Electrical Top-level Diagram Example for ORC Reviews Uses information from the T1068 installation as an example, ORC Review Conducted 12-02-2015

**Steve Chappa
03-23-2016**

T1065 Pictures

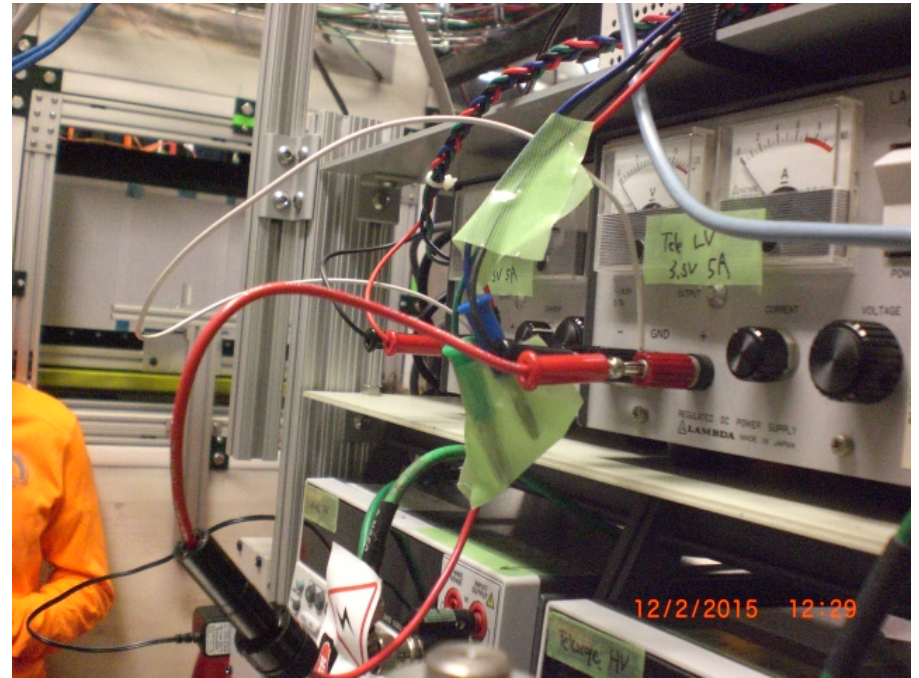
Shows the DC power supplies used

Notice that some power supplies have inline fuses installed at the output terminals.

Drawing Supplied by Installers/Users

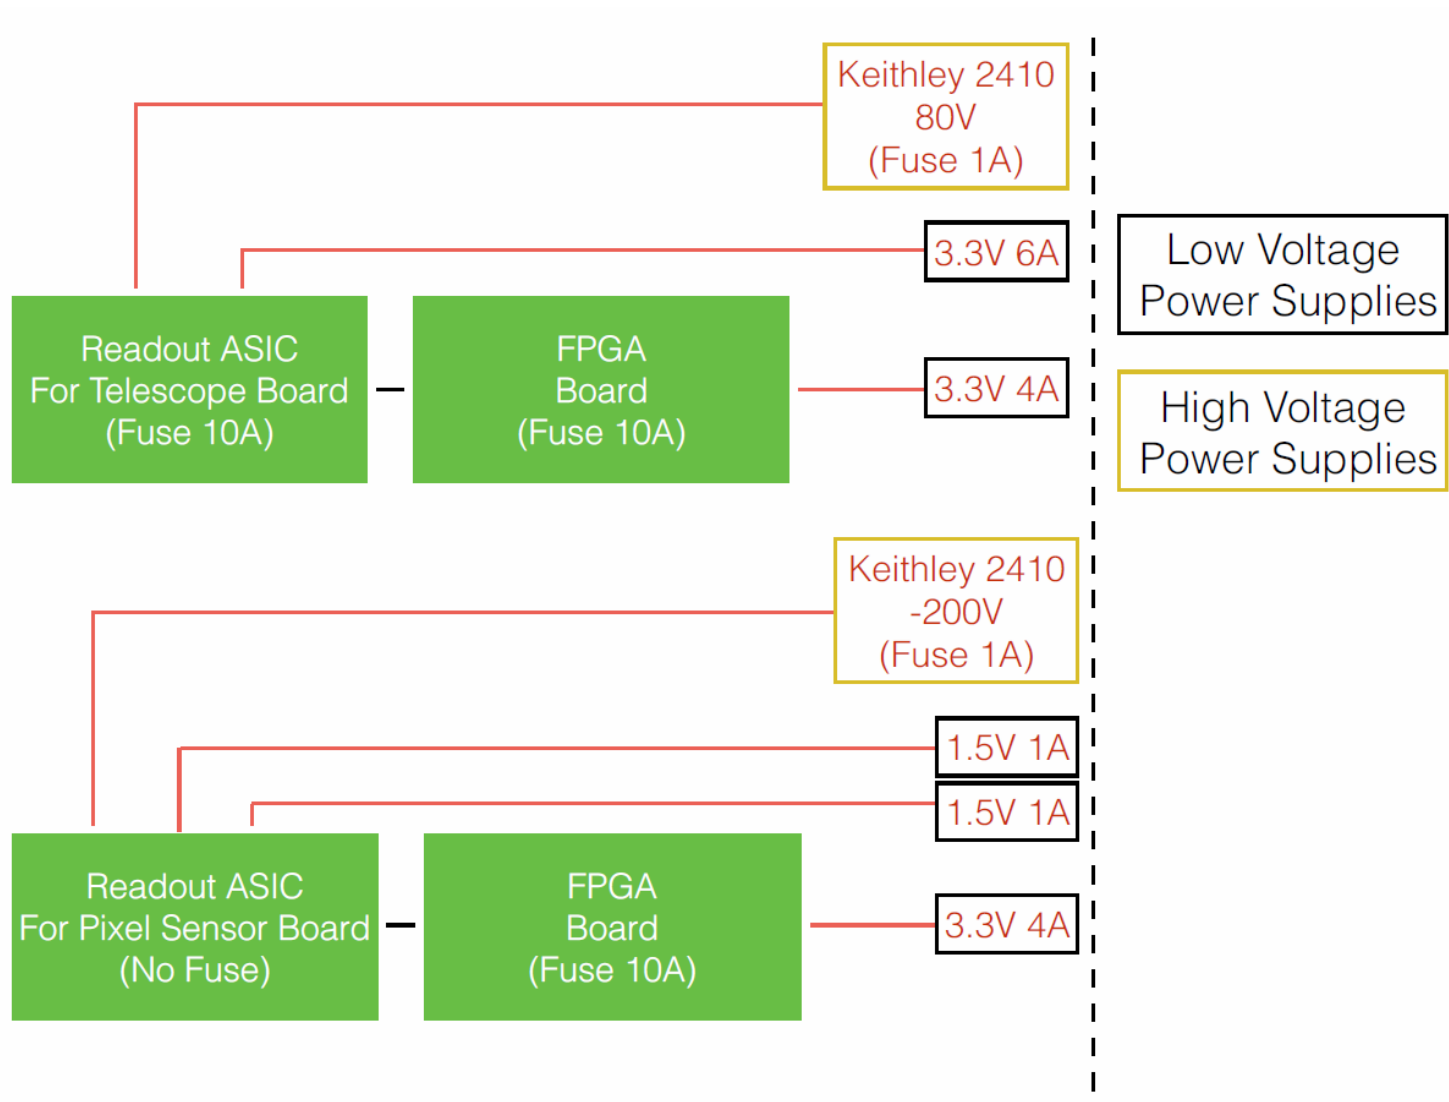
Insufficient information. This drawing can describe either a satisfactory installation (safety-wise) or an incorrect installation.

- What are the sources of the DC power used?
The supplied diagram does not indicate if the power supplies are bench type, AC-DC “brick” style with terminal connections, etc. Can they supply voltages over 50 VDC?

- What are the type/size of the DC conductors used?
The supplied diagram does not describe these conductors as wires, cables, twisted pair, etc.
- Where/How are the power supplies connected to the AC power?
Not shown. Are AC power cords plugged directly into a wall outlet, or power strip(s)? Are modules mounted in a crate? In a relay rack? Any rack protection used?

- What are the DC power supplies’ output ratings?
The supplied diagram does show a voltage and current. In this context, the current needs to be the maximum available output, NOT the usage current as determined by the load.

- Is DC power supplied to any load, either from the power supply or from one PC board to another PC board, over a ribbon cable?
The supplied diagram indicates what may be a cable connection from the ASIC PC board to an FPGA PC board. However, there is no description of this connection.

- Are there DC or AC experimental or bias high-voltages (HV, defined as any voltage over 50 volts) used or produced?

The supplied diagram does indicate two supplies with voltage sources over 50 volts plus a PMT that used about 1 kV DC (experimental high voltage).

- What, if any, fuse protection is used?

There are fuse values indicated. However, the location of these fuses is unclear (at the power supply output terminals, inside the supply, etc.?)

There also are fuse values shown on the PC board block symbols.

- What type of connectors/connection is used to connect the PC boards (or other loads) to the DC power conductors, part numbers (if available), and current ratings?

The supplied diagram does not describe any DC power connector/connection type used.
